Subject: Implementing ultra-precision flat carrier tape and heat activated cover tape

PCN #: PCN-01340

PCN Number: PCN-01340		PCN Date: May 29, 2019	
Title: Tape and reel carrier tape change			
Proposed first Ship Date: June 2020		Estimated Sample Availability/Qualification Completion: On request	
Proposed last Ship Date:			
Change Classification: Major <input type="checkbox"/>		Minor <input checked="" type="checkbox"/>	
Change Type:			
Assembly Site <input checked="" type="checkbox"/>		Design <input type="checkbox"/>	
Test Site <input type="checkbox"/>		Electrical Specification <input type="checkbox"/>	
Test Process <input type="checkbox"/>		Assembly Process <input type="checkbox"/>	
		Mechanical Specification <input type="checkbox"/>	
		Assembly Materials <input type="checkbox"/>	
		Packing/Shipping/Labeling <input checked="" type="checkbox"/>	
PCN Details			
Description of Change:			
<p>The carrier tape is being converted from raised channel to an ultra-precision flat pocket with tighter tolerances.</p> <p>In addition, the cover tape will change From Pressure Seal (PSA) 3M 2668 to Pressure Seal (PSA) 3M 2698.</p> <p>Dimensions and shape for carrier tape changes are shown below

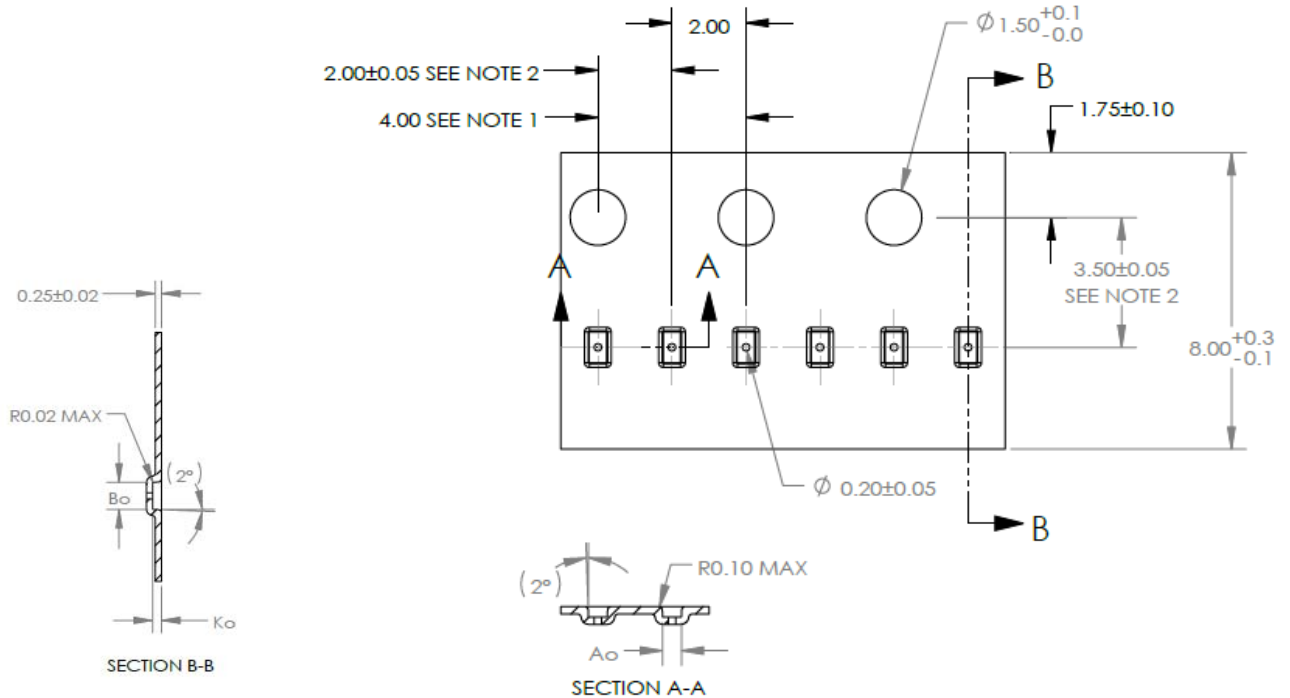
In accordance with these goals, this communication is to inform you that MACOM is updating the carrier tape pocket tape and cover seal tape for the part number listed below.

Minimize the die out of pocket and the die sticking to cover tape due to mechanical adhesion and for ease of assembly.

DIM	±
A ϕ	0.51	0.03
B ϕ	0.87	0.03
K ϕ	0.28	0.03
